UNITED STATES PATENT AND TRADEMARK OFFICE

APPLICATION NO.	FILING DATE	FIRST NAMED INVENTOR	ATTORNEY DOCKET NO.	CONFIRMATION NO.
10/705,898	11/13/2003	Seong Moh Seo	8733.017.20-US	6102

Office Action Summary

DETAILED ACTION

FIG. 1A
Prior Art

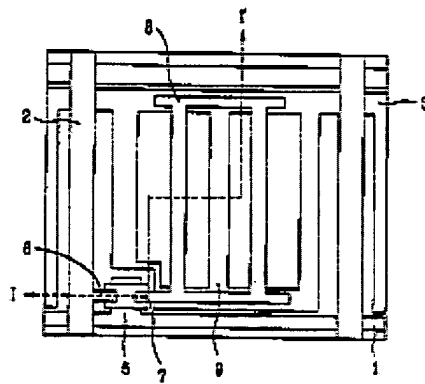
5. The AAPA described in pages 2-4 and shown in Figs. 1A-1B (reproduced below), discloses a liquid crystal display device comprising:

- first and second gate lines (1) arranged substantially in parallel above the substrate;
- a bus line (2) arranged to intersect the first and second gate lines to define a pixel ;
- a transistor having a source electrode (6) and a drain electrode (7) formed near an intersection part of the bus line (2) and the first gate line (1), the source electrode (6) being connected to the bus line (2);
- at least one data electrode (8) connected to the drain electrode (7) of the transistor;
- a passivation layer (20) formed above the transistors and the at least one data electrode (8); and
- at least one common electrode (9) and the at least one data electrode (8) engaged in an in-plane switching mode;

The AAPA differs from the claimed invention because it does not explicitly disclose that the common electrode is formed above the passivation layer.

FIG. 1B
Prior Art

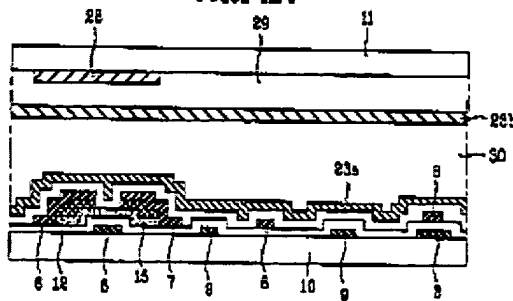
Further, it is clear from Fig. 1B of the AAPA that the second gate line has no overlapping portions with the data electrode (8) and the common electrode (9) as well as the data electrode (8) having no overlapping portions with the common electrode (9).

As to claim 28, the admitted prior art described in the present application also shows in Fig. 1B that the device further comprising:

- a second substrate (11) formed above the first substrate (10);
- a first alignment layer (23a) formed above the passivation layer (20);
- and
- a second alignment layer (23b) formed on the second substrate (11).
